RE: Oconee Nuclear Station  
Docket Nos. 50-269, -270, -287

Pursuant to 10CFR50, §50.90, please find attached a proposed amendment to the Technical Specifications for the Oconee Nuclear Station, Appendix A to Facility Operating Licenses DPR-38, -47, and -55. This proposed amendment incorporates changes to the pressurization, heatup and cooldown limitations for Oconee Unit 3. These changes are based on the attached report, "Analysis of Capsule OCIII-A from Duke Power Company Oconee Unit 3 Reactor Vessel Materials Surveillance Program", BAW-1438, July, 1977.

### 3.1.2 Pressurization, Heatup, and Cooldown Limitations

Figure 3.1.2-1C

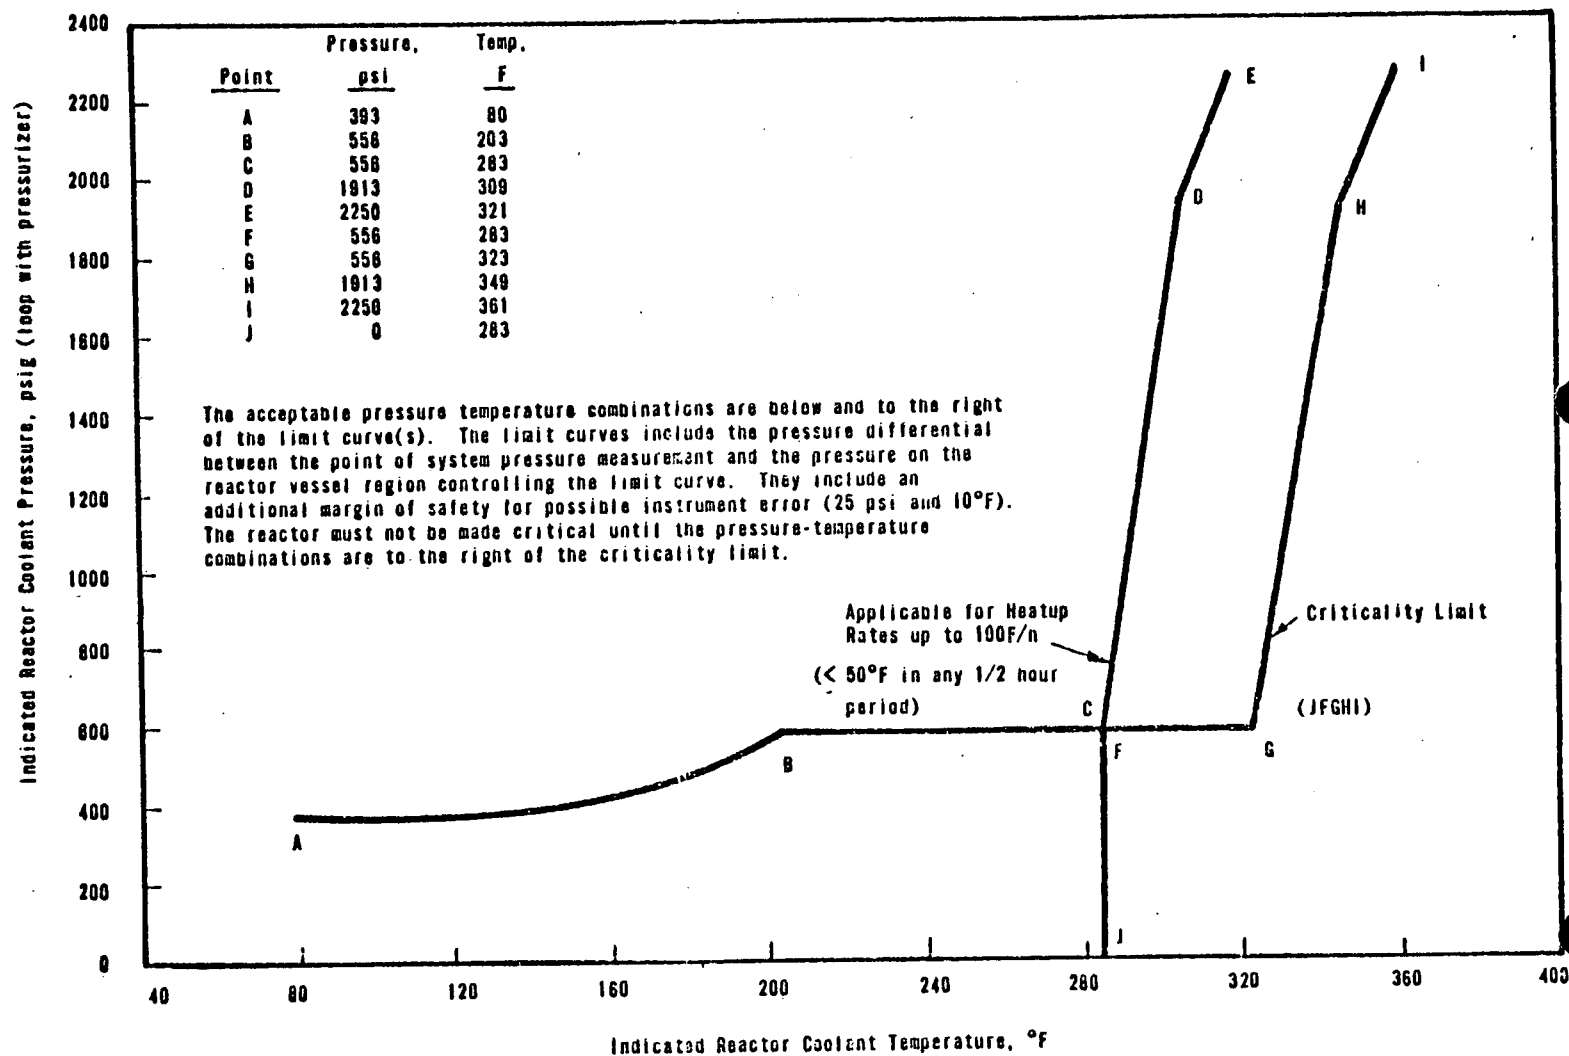
UNIT 3  
 REACTOR COOLANT SYSTEM  
 NORMAL OPERATION HEATUP LIMITATIONS  
 APPLICABLE FOR FIRST 8.0 EFY

Figure 3.1.2-2C

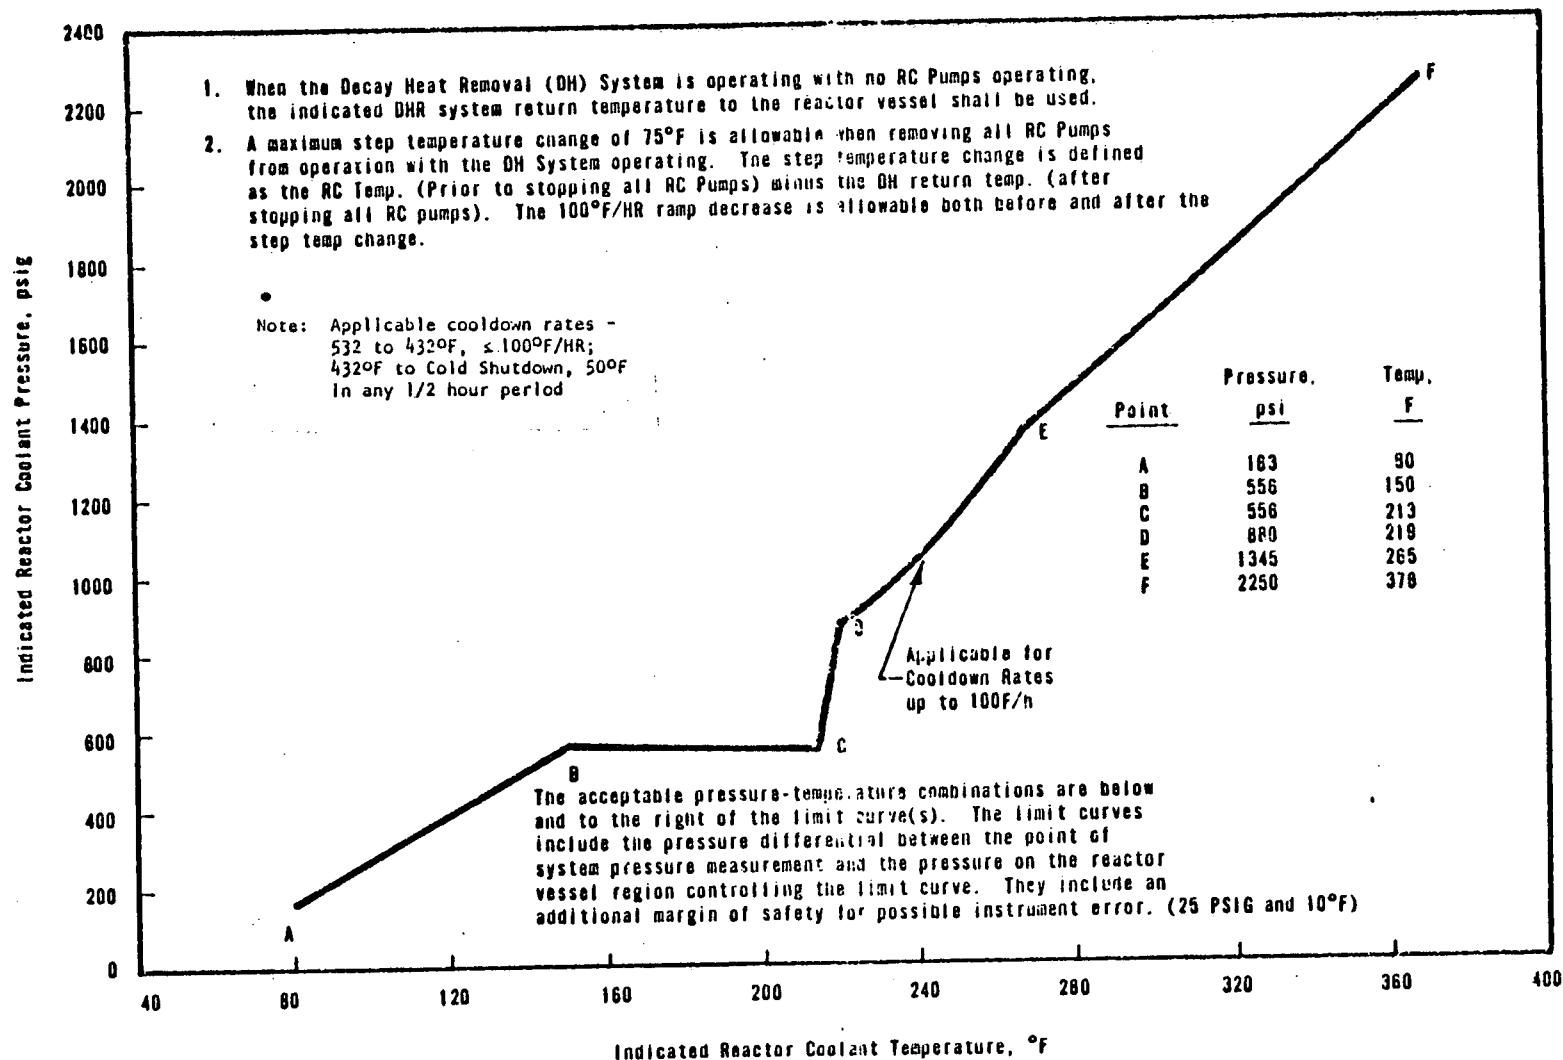
UNIT 3  
REACTOR COOLANT SYSTEM  
NORMAL OPERATION COOLDOWN LIMITATIONS  
APPLICABLE FOR FIRST 8.0 EFY

Figure 3.1.2-3C

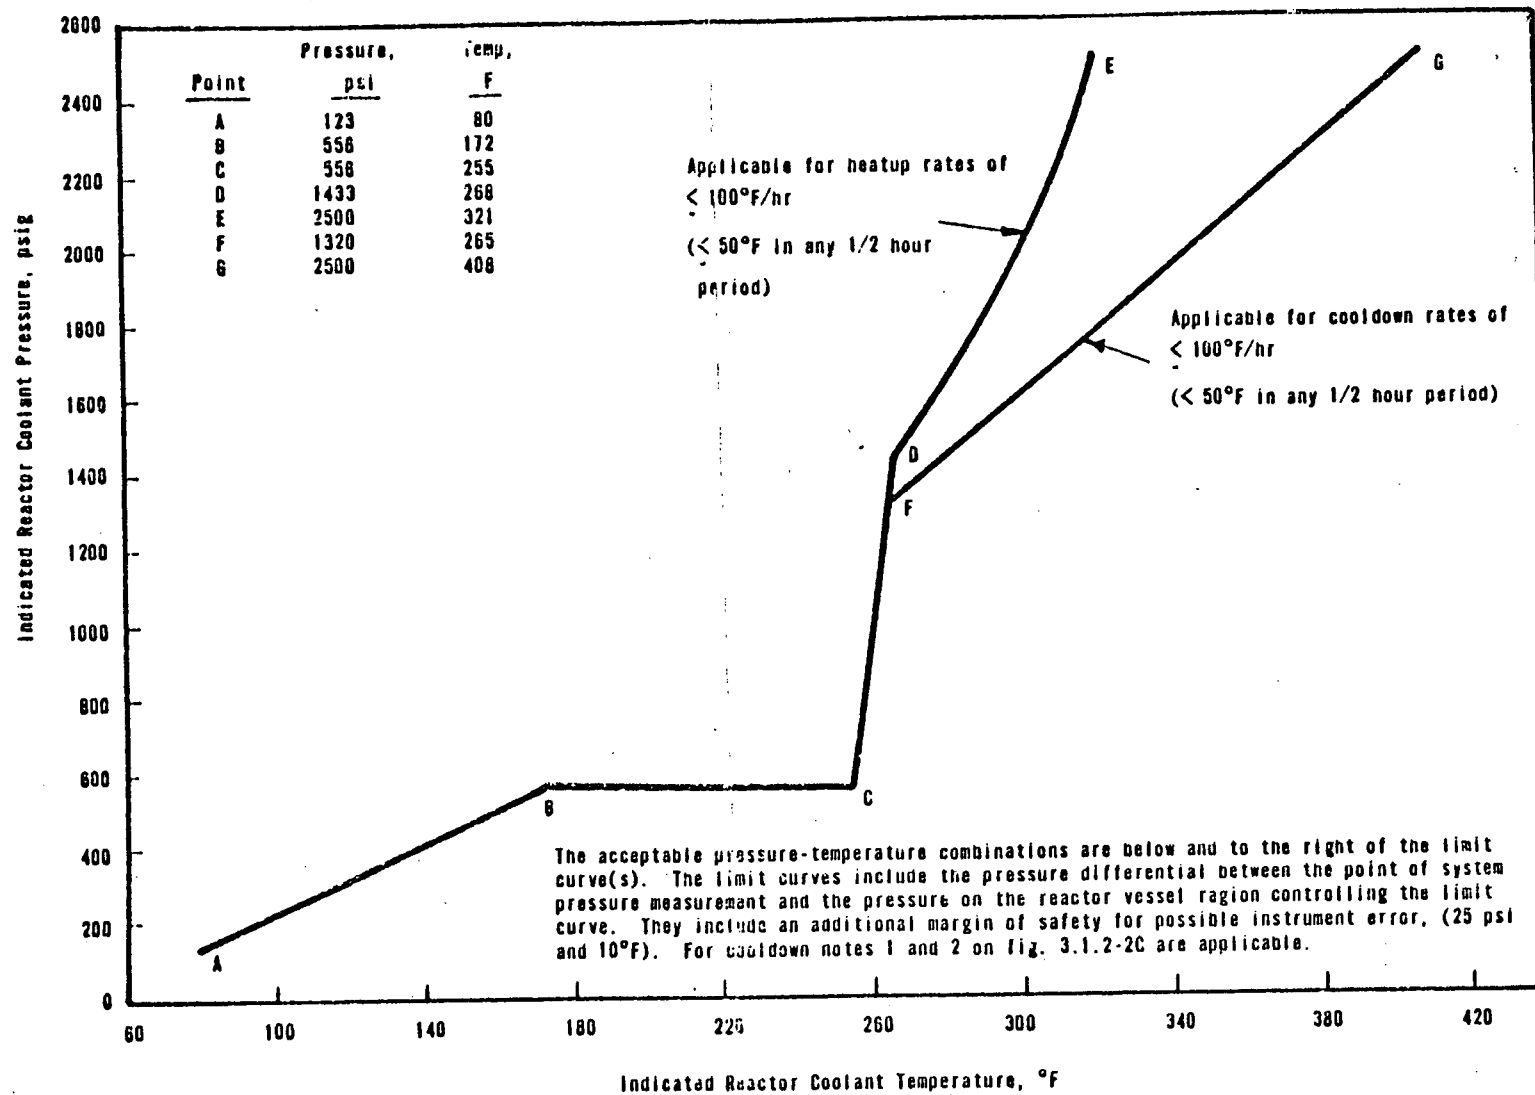
UNIT 3  
 REACTOR COOLANT SYSTEM  
 INSERVICE LEAK AND HYDROSTATIC  
 TEST AND COOLDOWN LIMITATIONS  
 APPLICABLE FOR FIRST 8.0 EFY
